# Zaheen Knitwears Limited

(Shed - 3, 4, 5, 10, 11, 12, 13) &  
(Building - Security, ETP and Fire Pump)

19 September 2022

# Observations

# Lack of lateral stability

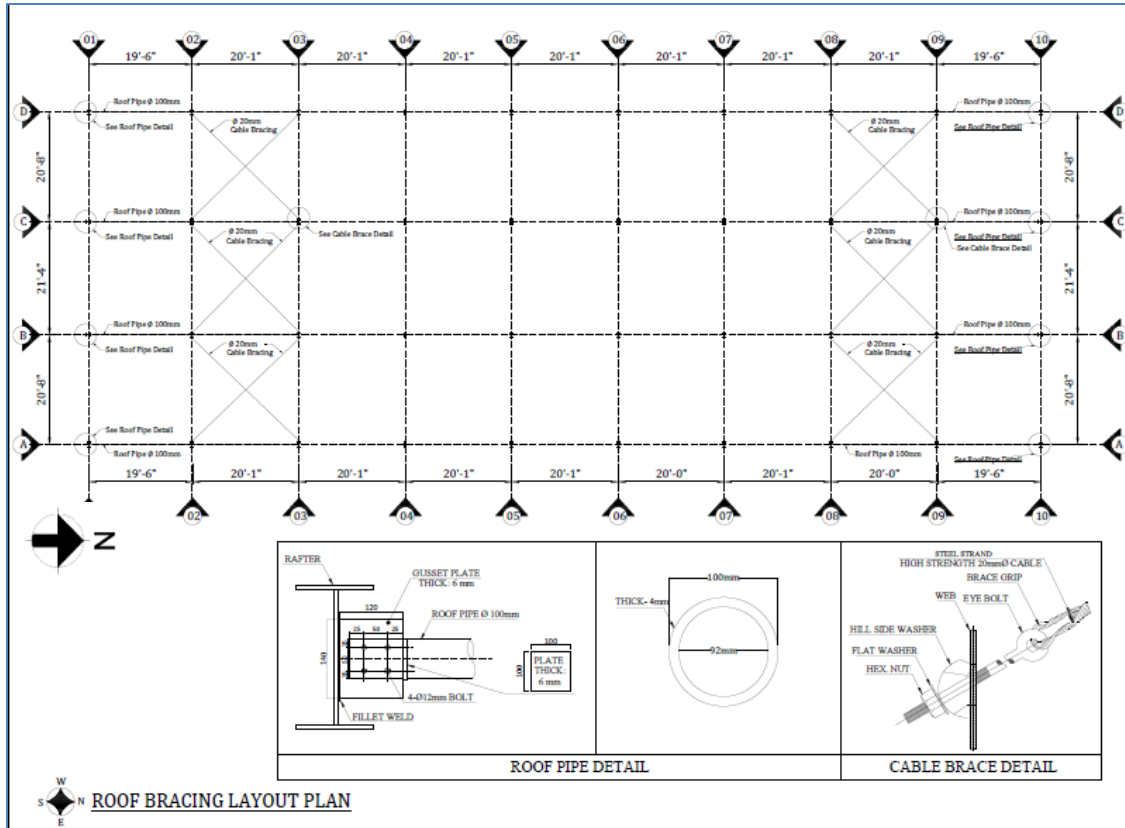
Load transfer media is not provided at first floor along long direction.

Load transfer media is missing at first floor along long direction

Lateral stability system of the shed has been checked by the building engineer. Retrofitting work is proposed. The factory has not implemented the retrofitting works yet.

Strut pipe and cable bracing are proposed in retrofitting drawing.

Retrofitting work is not implemented

**Observation: Shed -3 (Garments Shed)**

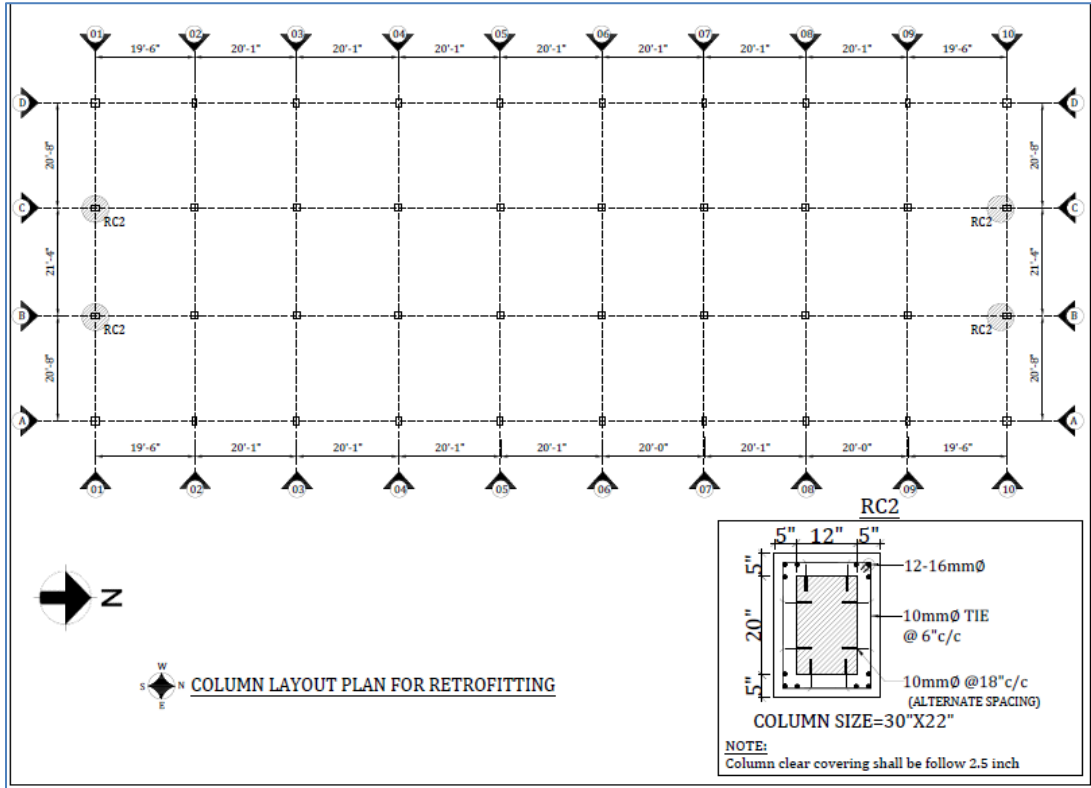
Retrofitting is proposed for RC pedestal column

Retrofitting work is not implemented

Sub beam layout

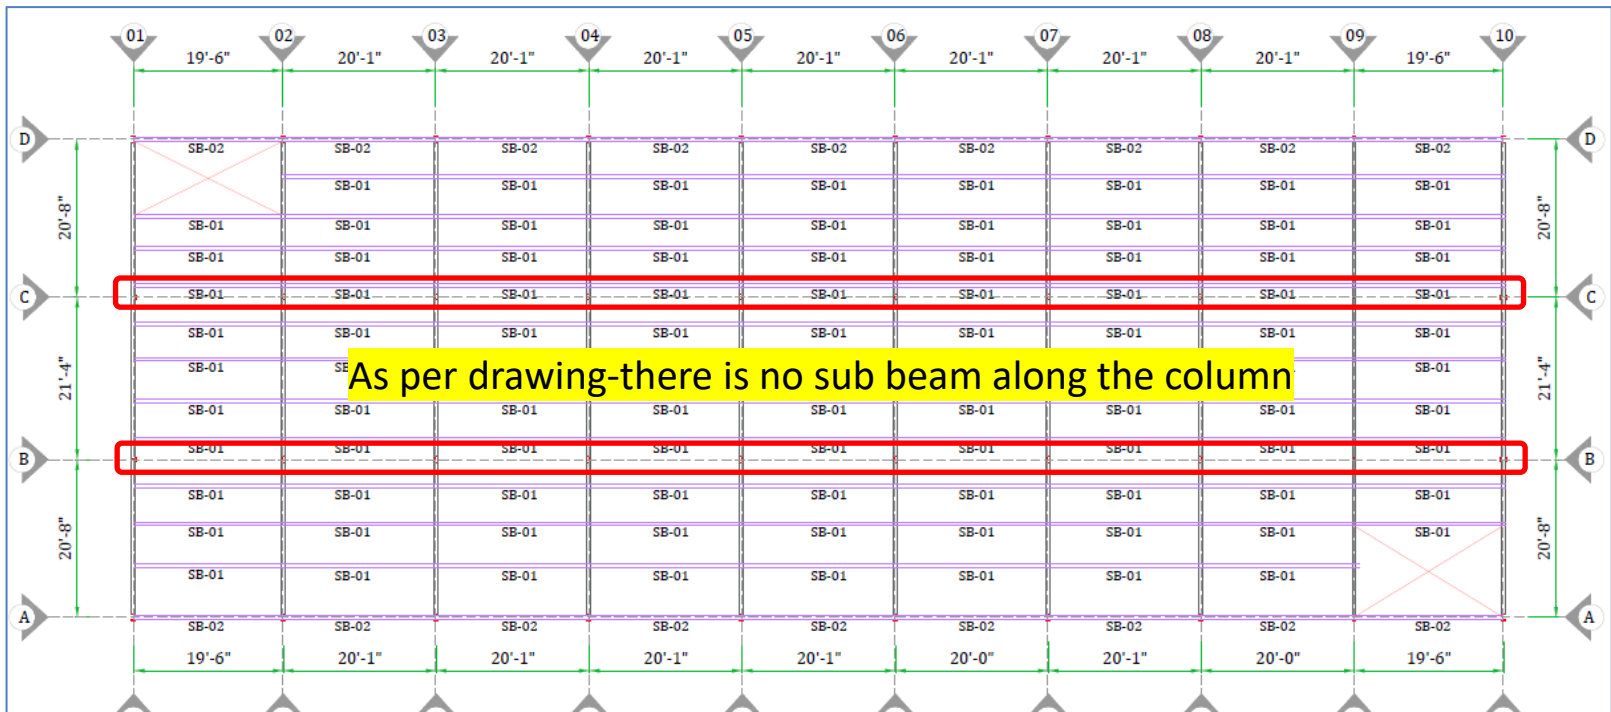
As per as built drawing sub-beams are not connected with the column. But on-site condition (marked grid) sub-beams are connected with columns. Building engineer is required to survey the whole structure and produce accurate as-built drawings.

Sub beam & column connection

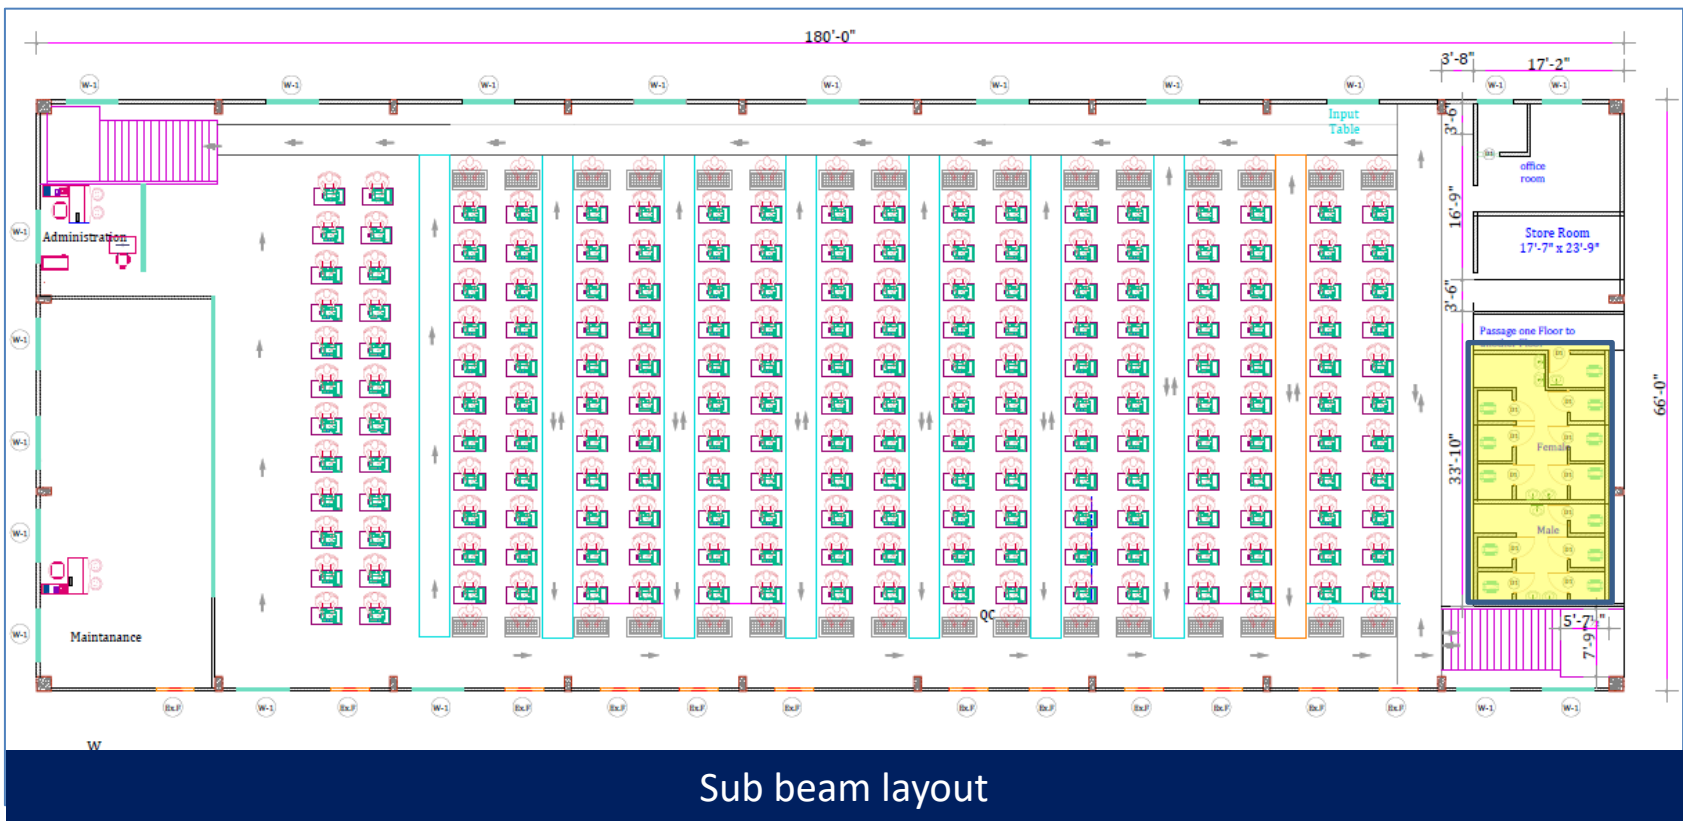
Toilet build up at 1<sup>st</sup> floor are not shown in architectural drawing. Building engineer is required to survey the whole structure and produce accurate as-built drawing.

Toilet Build up (230 mm)

**Lateral stability to be checked**

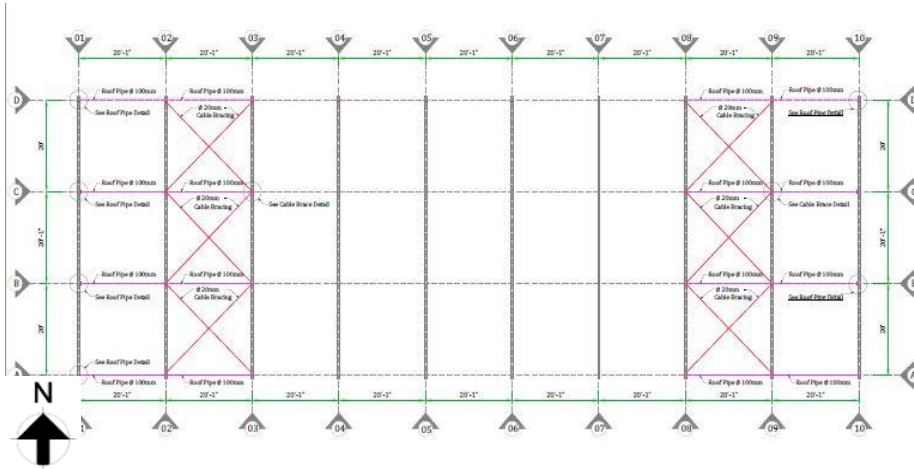
Load transfer media is missing at most of the location along long direction

Load transfer media is provided at some locations along long direction

Roof and wall bracing are provided. Load transfer media is provided at some locations but load transfer media is missing at most of the location along long direction. Therefore, lateral stability system of the shed is apparently incomplete. Building engineer is required to check the lateral stability of the structure.

Bracing location shown in layout

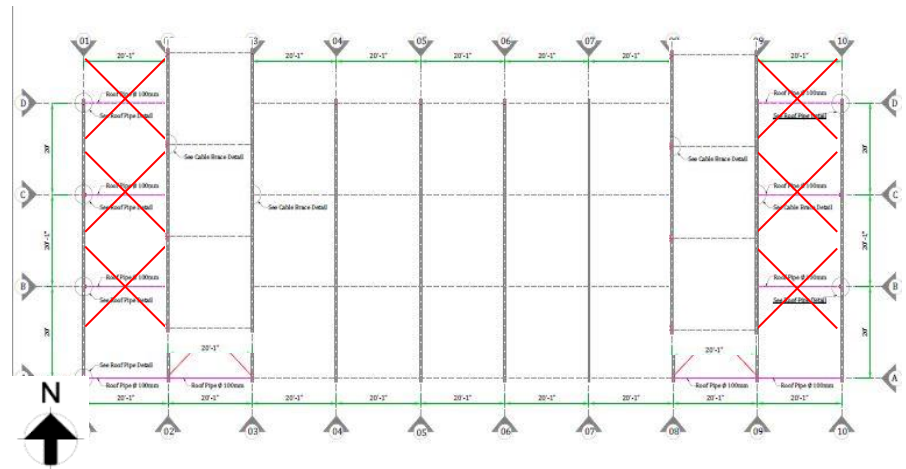
Bracing location found on site

Roof and wall bracing are found at different location of bracing layout plan shown in drawing. Building engineer is required to update the as-built drawing and check the lateral stability of the structure.

Bracing location shifted

Retrofitting (additional plate installation) is proposed for steel beam

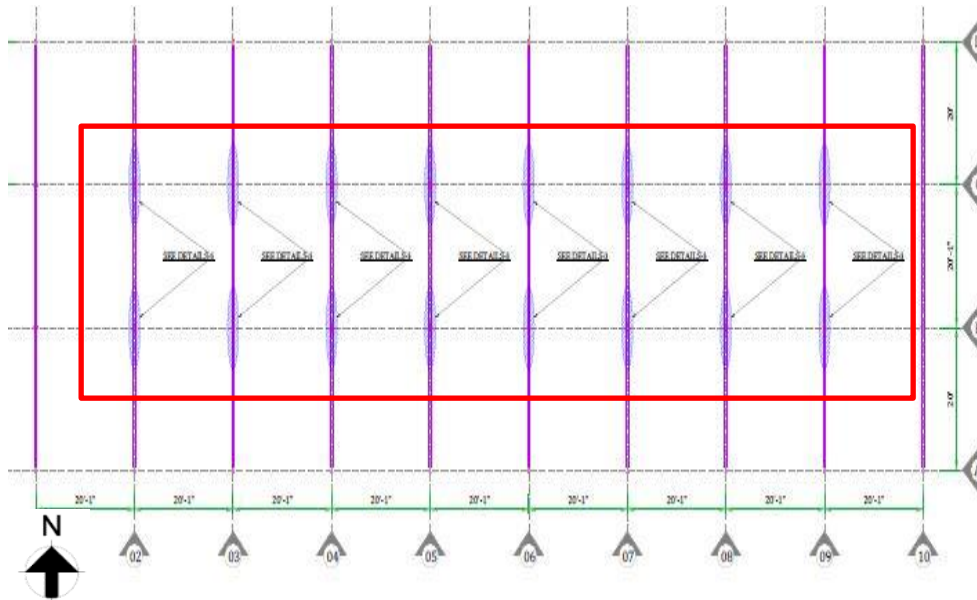
Lateral stability system and member adequacy of the shed has been checked by the building engineer. Retrofitting work is proposed. The factory has not implemented the retrofitting works yet.

Retrofitting is proposed for RC pedestal column

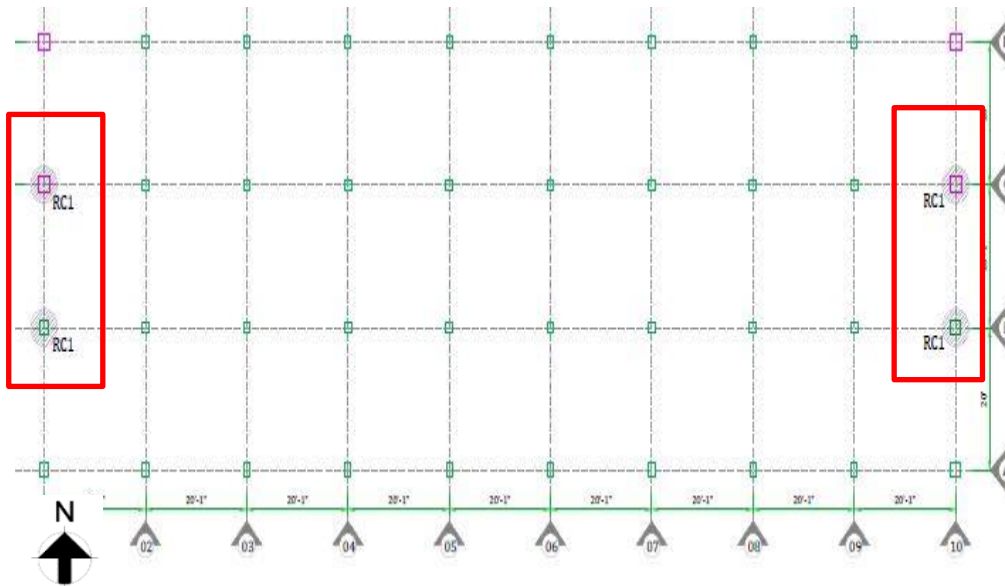
Retrofitting work is not implemented

Retrofitting work is not implemented

# Incomplete lateral stability system

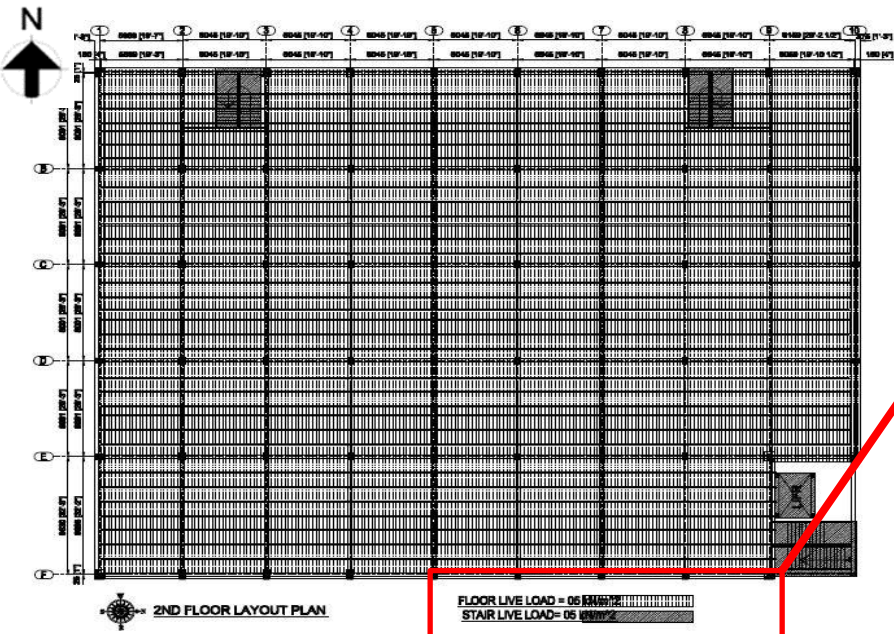
No load transfer media is provided along long direction

Roof and wall bracing are provided but load transfer media is not provided along long direction for this shed. Therefore, lateral stability system of the shed is apparently incomplete. Factory engineer is required to check the lateral stability of the structure.

# Discrepancy in as-built drawing

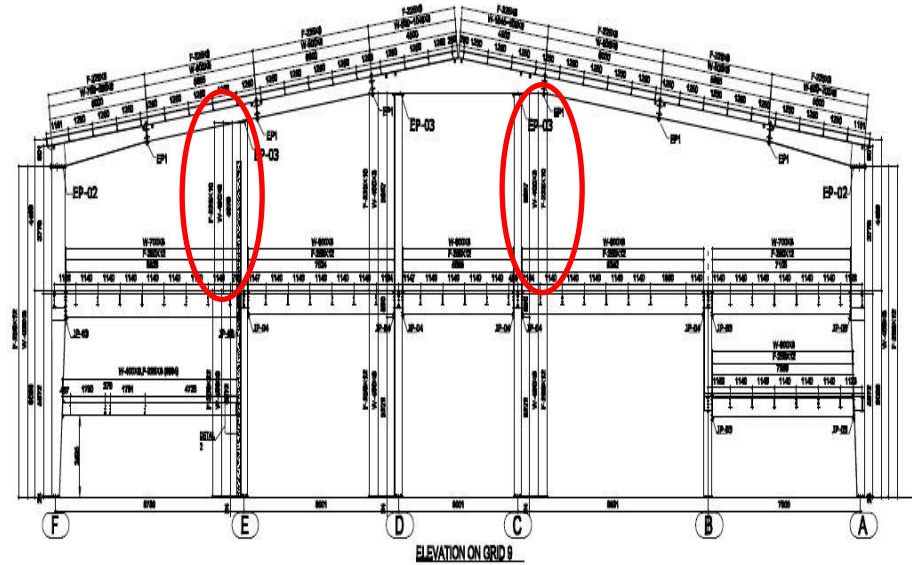
One internal column found at every grid along ridge at first floor

Marked column shown in drawing but not found on site from grid 2 to grid 9

One internal column found at every grid along ridge at first floor. Marked column shown in drawing but not found on site from grid 2 to grid 9. Building engineer is required to survey the whole structure and produce accurate as-built drawing.

# Gap in connection at several location

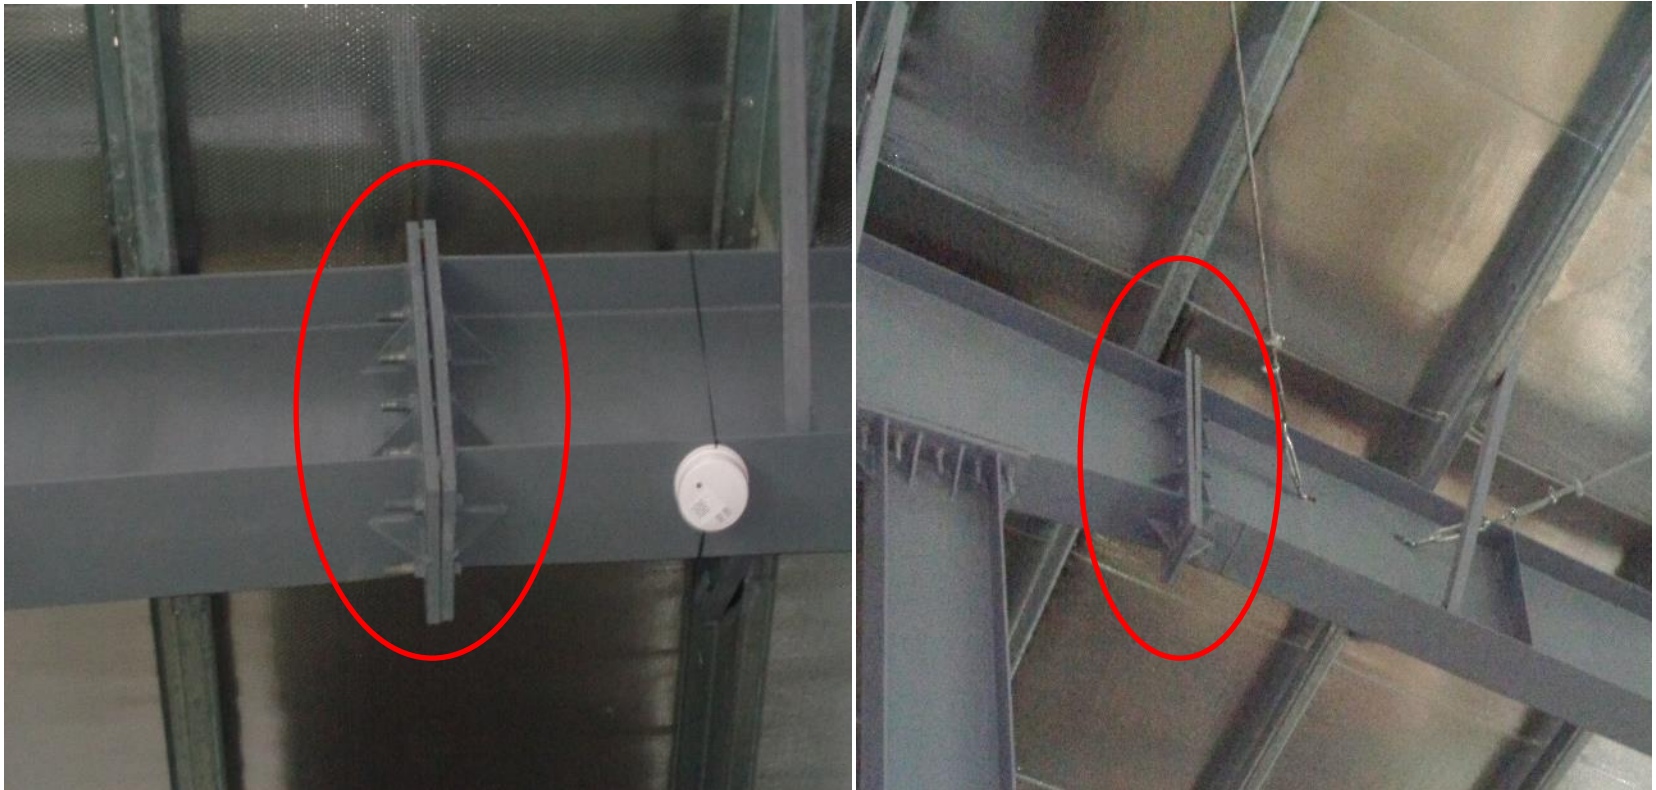
Gap was observed in connection

Gap was observed in connection of steel members. Building engineer is required to repair the connections with suitable method suggested by building engineer.

# Crack on brick wall

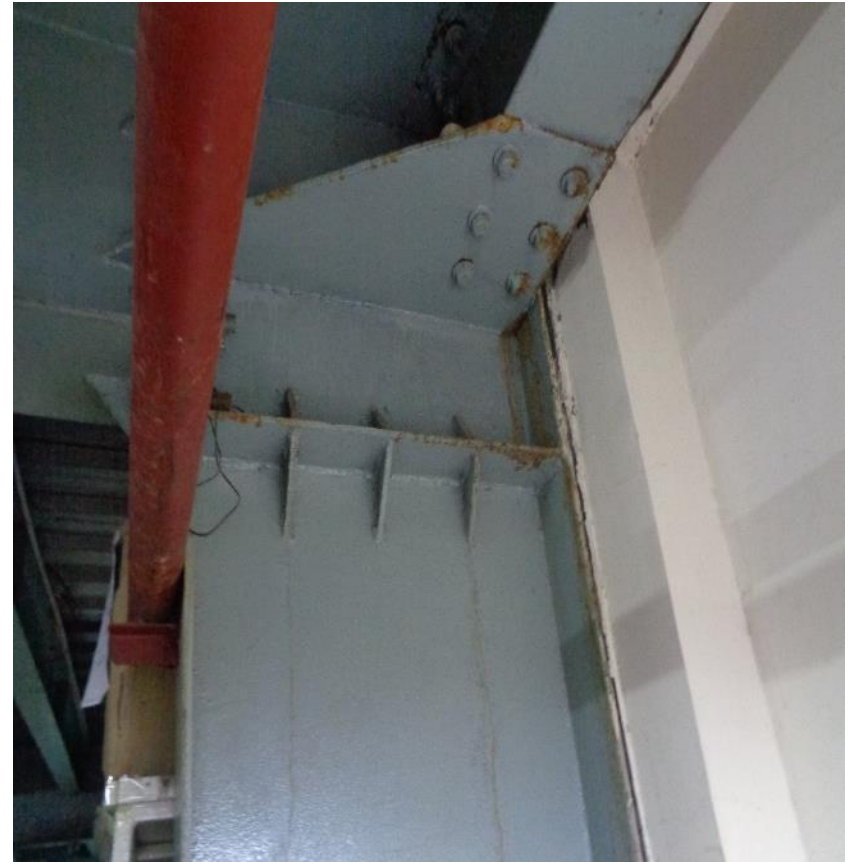
Crack observed on brick wall at several locations

Crack observed on brick wall at several locations. Building engineer is required to instigate the reason of the crack and repair with a suitable method.

Apparently inadequate connection

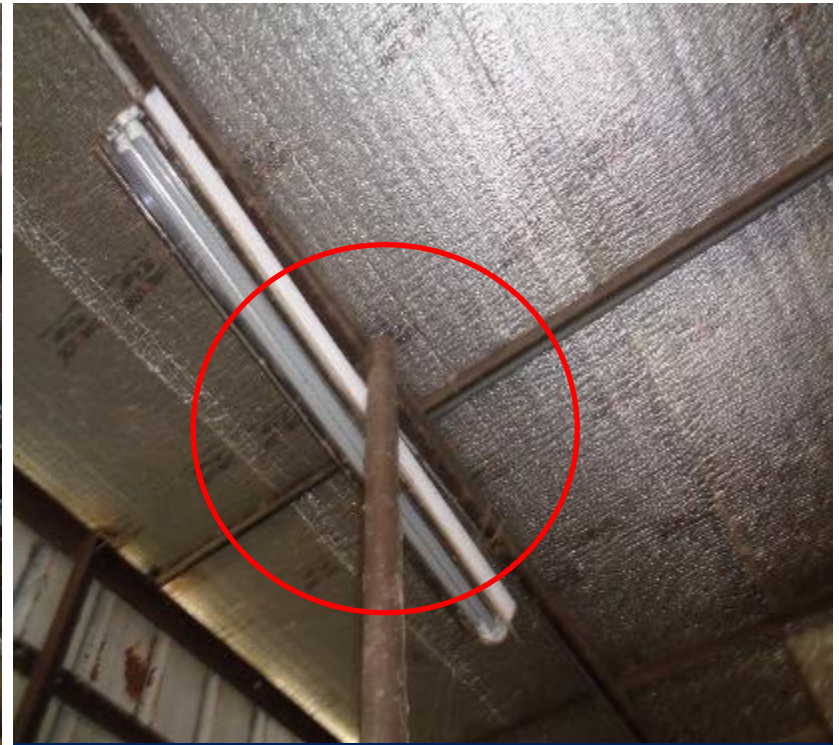
Apparently Inadequate structural member, poor connection details were found. Building engineer is required to check the adequacy of the steel members & connection for uplift and lateral forces otherwise replace with engineered structure.
